Architectural Review Committee Staff Report Meeting Date: August 19, 2025

PETITION: McCordsville Commerce Center Lot 2 Architectural Design

REQUEST: Petitioner requests approval of their design for a +/- 94,549 SF industrial building

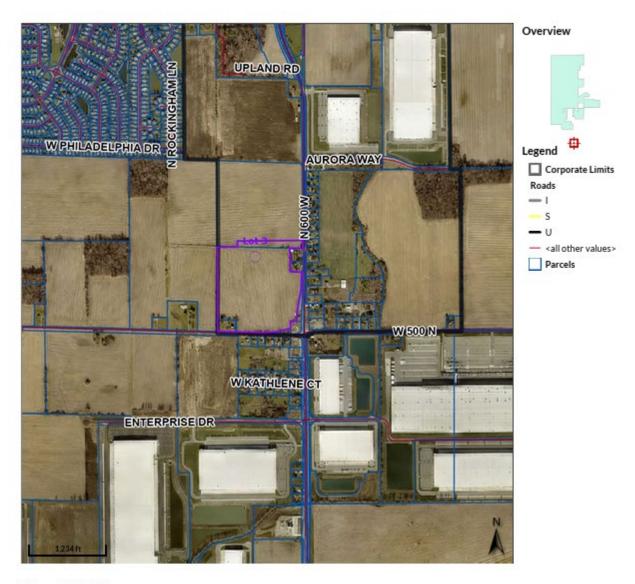
as wall sconces, building mounted accent lights, or decorative pedestal lights. *Staff finds this requirement has been met, as the primary customer entrances incorporate a recessed storefront with sidelights and transoms, accent-colored materials with reveals, and enhanced exterior lighting.*

- Façade colors shall be low reflectance, subtle, neutral hues or colors. The use of high-fluorescent colors shall be prohibited. Building trim and accent areas may feature brighter colors or primary colors, provided the building trim and accent areas do not exceed 10% of any single exterior façade exclusive of all windows, doors, or other building openings. Building trim and accent areas featuring brighter colors or primary colors in excess of 10% of any single exterior façade shall be submitted for review by the Architectural Review Committee. Staff finds this requirement has been met, as the proposed façade colors are low-reflective neutrals with darker accent panels that appear to cover less than 10% of any single façade.
